UNITED STATES PATENT AND TRADEMARK OFFICE

APPLICATION NO.	FILING DATE	FIRST NAMED INVENTOR	ATTORNEY DOCKET NO.	CONFIRMATION NO.
10/694,723	10/29/2003	Jeffrey Allen	PA1425	4035
28390	7590	08/08/2006	EXAMINER	
MEDTRONIC VASCULAR, INC.			HOUSTON, ELIZABETH	
IP LEGAL DEPARTMENT			ART UNIT	
3576 UNOCAL PLACE			PAPER NUMBER	
SANTA ROSA, CA 95403			3731

Office Action Summary

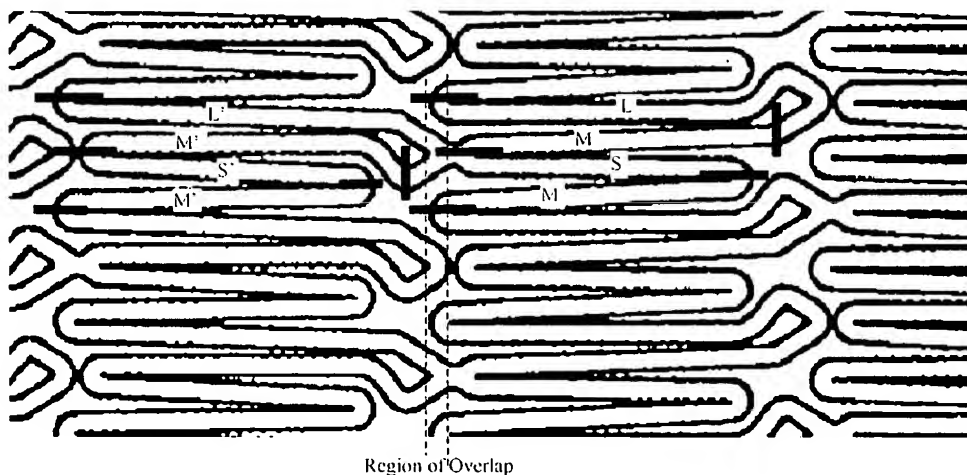
15. Lowe discloses a stent in Figures 23 and 24. The figure is copied and labeled below to depict the long segment (L), first peak (1P), midsize segment (M), first valley (1V), short segment (S), second peak (2P), and second valley (2V). It should be clear that the first peak turn of one element is connected to the first valley turn of an adjacent element. Each element (except the first and the last) has a first connection point connecting it to an adjacent element and a second connection point connecting it to a second adjacent element. The connection points form a double helix pattern. The

For the purposes of claims 19-22 the following interpretation applies. The heavy black lines define where each segment begins and ends. The dotted lines define the area where the long segments overlap. The connection member spans between the long segment of the first element and the long segment of the second element because it extends between part of the long segment of one and part of the long segment of the other. Figures 11, 12 show embodiments where the connection is a sinusoidal.
